## **REVISED FINDINGS: COASTAL DEVELOPMENT PERMIT APPLICATION**

**Application number** ..... A-3-SLO-01-018, Gonyer SFD

**Applicant** ..... John Gonyer

**Project description** ..... Construct a single-family residence with a 1,029 sq. ft. footprint and 1,744 sq. ft. of gross structural area.

# BUILDING FOOTPRINT

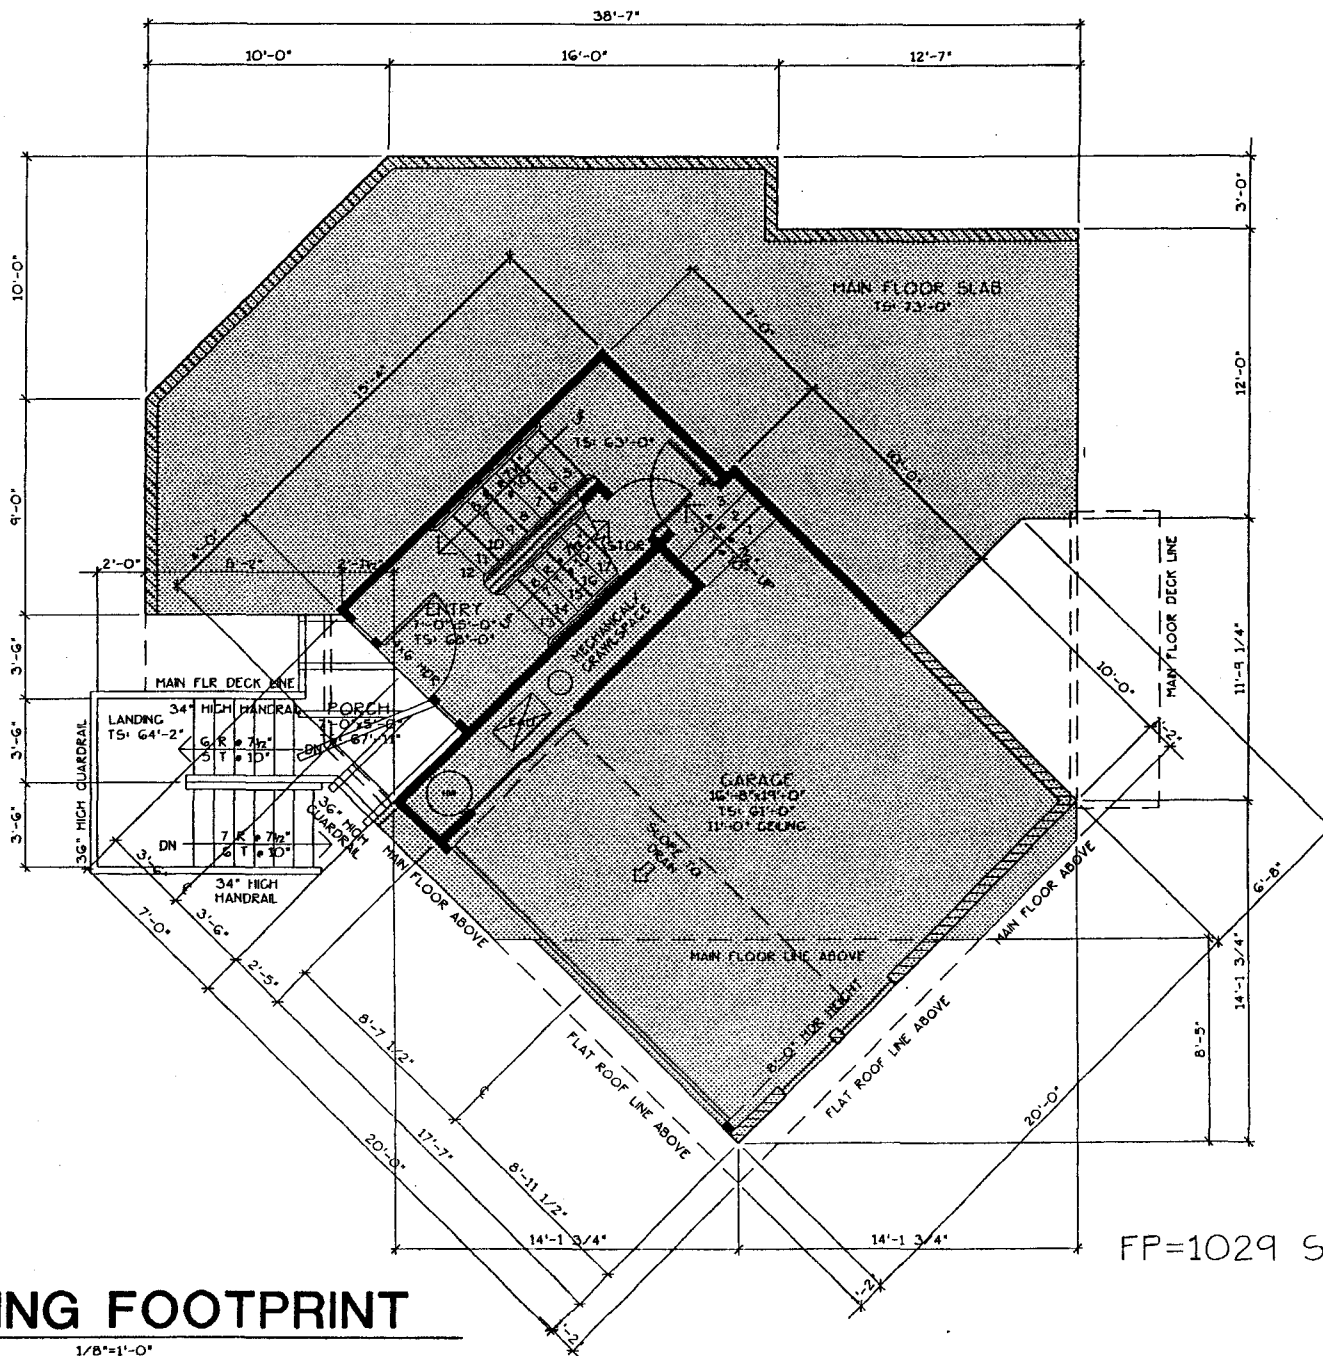
In addition, the footprint of the originally proposed residence has been calculated at approximately 1,160 square feet, which exceeds by the maximum footprint allowed under Table G by ~~429-100~~ square feet. The difference between this calculation and that submitted with the original plans is that the previously submitted calculation had not counted structural overhangs/covered deck areas as required by the LCP.

With these changes, the project has a total footprint of 1,029 square feet and a total gross structural area of 1,704 square feet. While this has achieved consistency with the LCP's limitation on footprint, the revised plans still exceeds the LCP maximum on Gross Structural Area. Thus, the conditions of revised project approval require the applicant to submit new plans that conforms to the maximum ~~1,034~~1,060 square foot footprint and ~~1,746~~1,696 square feet of gross structural area established by the LCP.

# MAIN FLOOR PLAN GSA

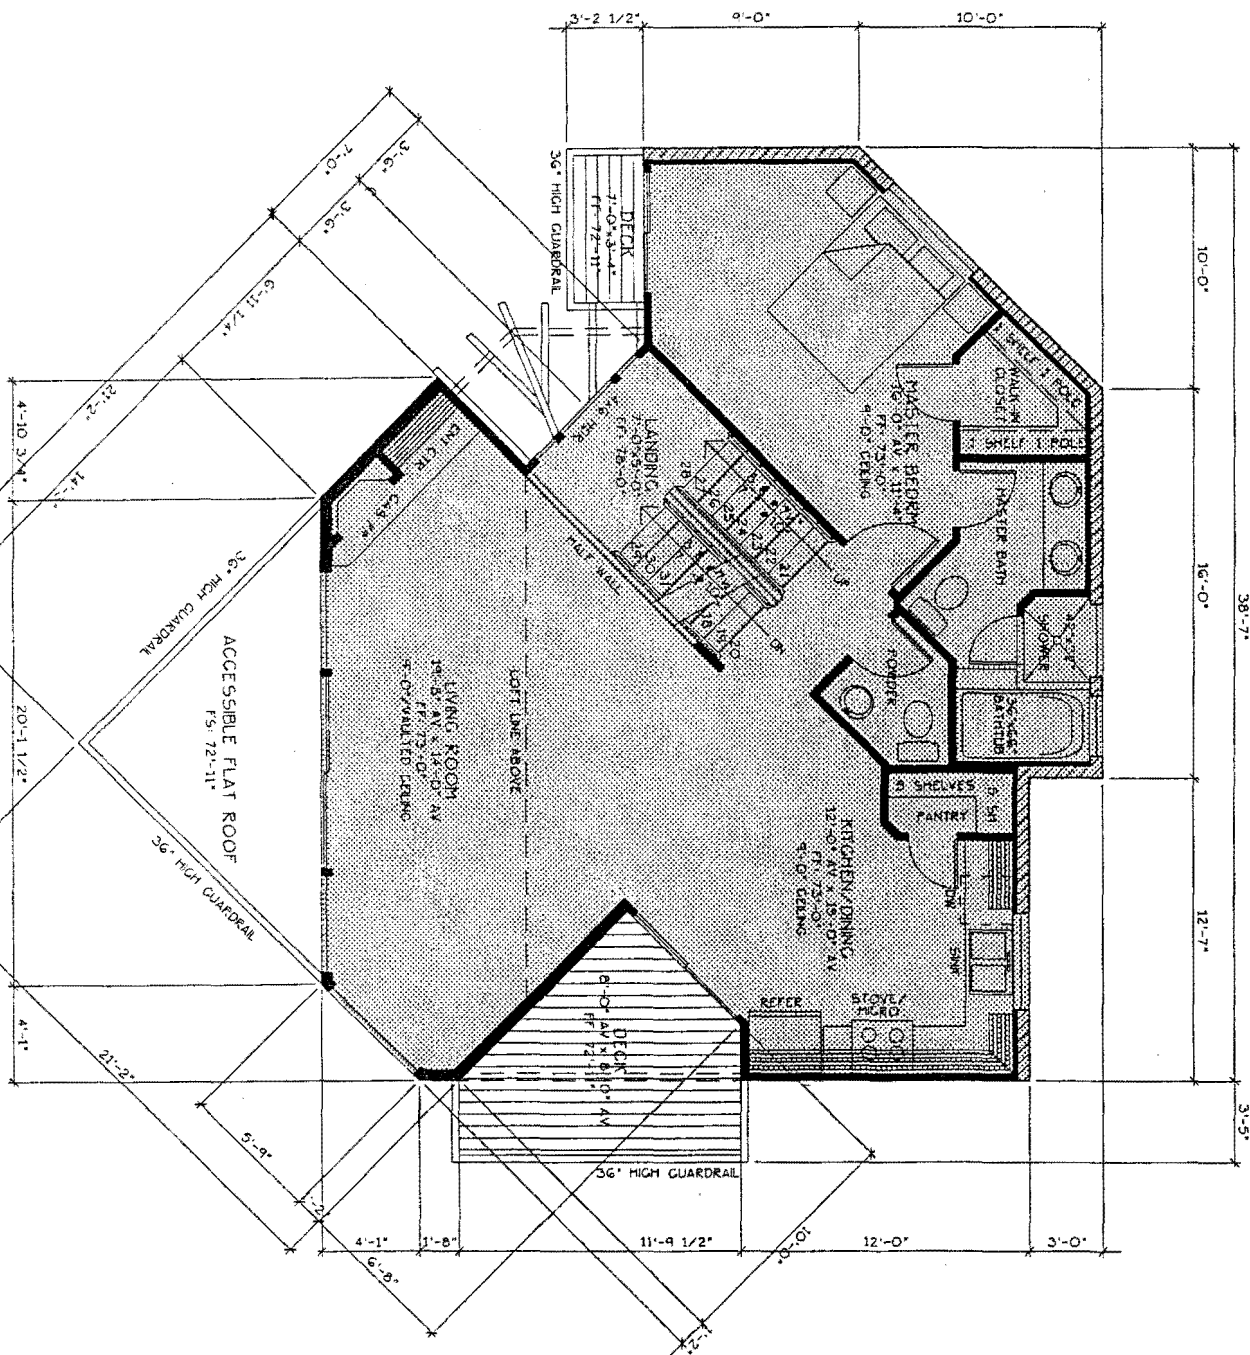
A strict reading of these definitions necessitates that, contrary to the County's typical practice, mechanical storage areas and crawl spaces be included as part of the Gross Structural Area, as they add to the total volume and floor area of the interior structure. Similarly, the footprint of the stairway must be considered as part of the building's structural area. However, consistent with typical industry practice and the LCP definition which states that Gross Structural Area should be expressed in square feet of floor area, it is appropriate to calculate the footprint of the stairway only once in determining gross structural area. This is because the stairway serves a single function, and does not add to the floor area of upper stories (as compared to mechanical storage areas, which can have floor area above). This methodology is consistent with state regulations for calculating square footage as part of real estate appraisals, established to prevent the exaggeration of structural floor area (see Exhibit 4). Commission staff also used this methodology in recent condition compliance review of final plans for the Victorian Inn, a development in Cayucos approved on appeal to the Commission that raised similar concerns regarding the amount of allowable square footage (please see Exhibit 6).
